### MINERALS PROGRAM INSPECTION REPORT

<b>MINE NAME:</b> Orphan View Gravel Pit	<b>MINE/PROSPECTING ID#:</b> M-2013-016	<b>MINERAL:</b> Borrow material for construction, gravel and sand	<b>COUNTY:</b> Huerfano
<b>INSPECTION TYPE:</b> Monitoring	<b>WEATHER:</b> Clear	<b>INSP. DATE:</b> February 13, 2025	<b>INSP. TIME:</b> 12:50
<b>OPERATOR:</b> Huerfano County	<b>OPERATOR REPRESENTATIVE:</b> Dustin Hribar	<b>TYPE OF OPERATION:</b> 112c - Construction Regular Operation

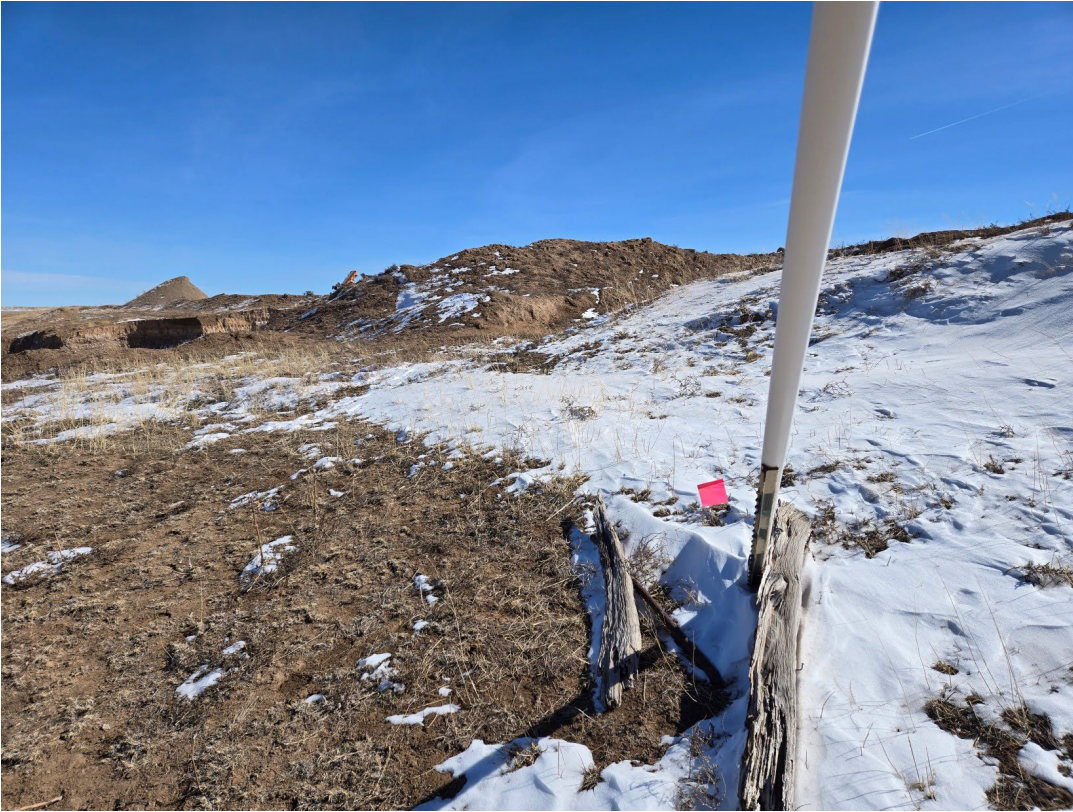
When reviewing the new map, and looking at recent disturbance at the site, it appeared that the southern topsoil pile, and the southern tip of recent disturbance on the southwest side, extends outside of the permit boundary to the south. When looking at the TR1 map, it also appears that the topsoil pile in the southeast corner is shown as extending past the new boundary. During the inspection, the Operator stated that the field markers had not been reconfigured since the original permit boundary and were assumed to match the map submitted with TR1. The Operator also stated that the field markers show that the southern disturbance is within the boundary. Five field markers (T-posts and PVC pipe extensions) were observed around the site. The Division collected the field markers during the 2025 inspection (Map 1; Photos 11- 15), compared them with marker locations collected during prior inspections, and agrees that the coordinates provided for the current map do not match the field markers, which was not the Operator's intention.

Lastly, when looking at aerial imagery, it appears that sometime between September 2013 and September 2019, a new entrance to the site was being utilized. This entrance can be seen on the aerial images included with the TR1 maps and in recent imagery Map 1. The original entrance extends directly south from County Road 640 into the pit via a pre-existing road (Figure 1). The new entrance is approximately 83 feet east of the old entrance and enters the pit at a northeast to southwest orientation (Photos 14-15). The new entrance is located within the same parcel as the rest of the mining operation. When asked about the new road, the Operator stated that there is a pipe that runs underneath the original entrance, and to prevent damage to it, the new entrance was created.

Due to the various issues highlighted above, this has collectively been **cited as a problem**. Because these issues are due both to mistakes made by the Operator and by the Division, this shall be remedied through a Technical Revision. The Operator shall submit a Technical Revision application that provides updated mining and reclamation plan maps where the permit boundary matches the boundary in the field, with the exception of the

entrance location. The entrance road must be included within the permit boundary. The permit boundary shall equal the approved 16.8 acres. Additionally, because highwalls are present onsite, but are not included in the current mining plan, the mining exhibit shall be updated to reflect current operations and how the mining at the site is planned to be conducted moving forward. A technical revision application with the required changes shall be received by the Division by the corrective action date.

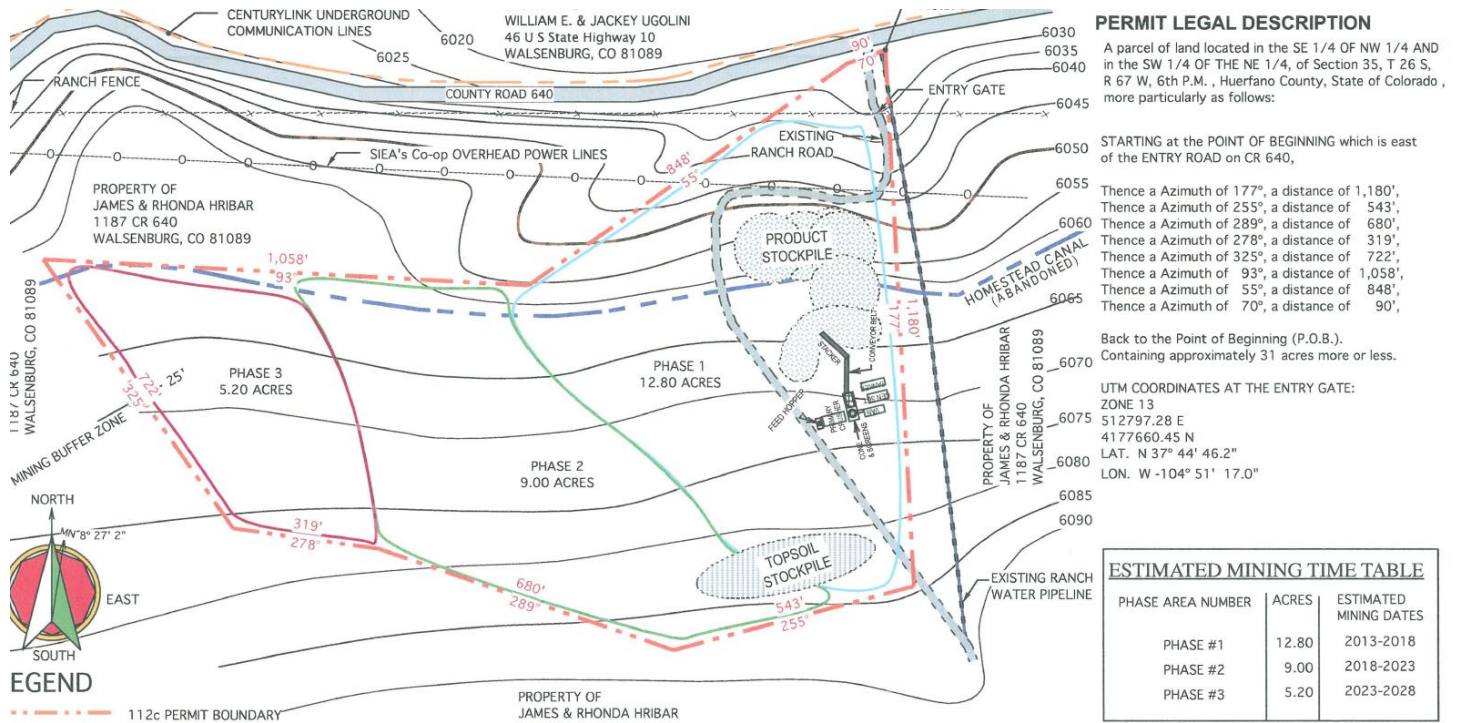
During the pre-inspection permit review, a few discrepancies were identified that occurred during the AR1/TR1 process. First, the shape of the phase boundaries were simplified on the acreage release description map submitted with TR1 (see Figure 1). Also, the phases were assumed to equal the acreages shown for each phase on the original mining plan map (Figure 1). However, the acreages shown on the original mining plan map correspond with the estimated acres to be mined, which does not equal the total acreage at the site.

Per the original phasing (see Table 1 above) the total mining area within each phase totaled 27 acres. When AR1 was requested and subsequently approved, Phases 1 and 2 were assumed to total 14.2 acres, which was subtracted from the *total* acreage of 31 acres, to equal the current 16.8 acres. Due to the changes in the phase boundaries, and the misunderstanding with the mining and phase acreages, the current permit boundary as depicted on the new mining plan map submitted with TR1 encompasses less than 16.8 acres. On the TR1 map, coordinates were provided for the southeast, southwest, northwest, and partially northeast new corner markers (see the Operator's current mining map enclosed with this report). The longitude coordinate for the NE permit marker was cut-off and not included on the current map. However, based on the three coordinates included, and the aerial image included with the current map, the Division estimates that the current boundary depicted on the map equals approximately 16 acres. Additionally, of the 16.8 acres, 12.8 acres is still the approved acreage (reported on file) to be disturbed at any one time. Due to the change in shape, this no longer appears to correspond with the current operating plan.
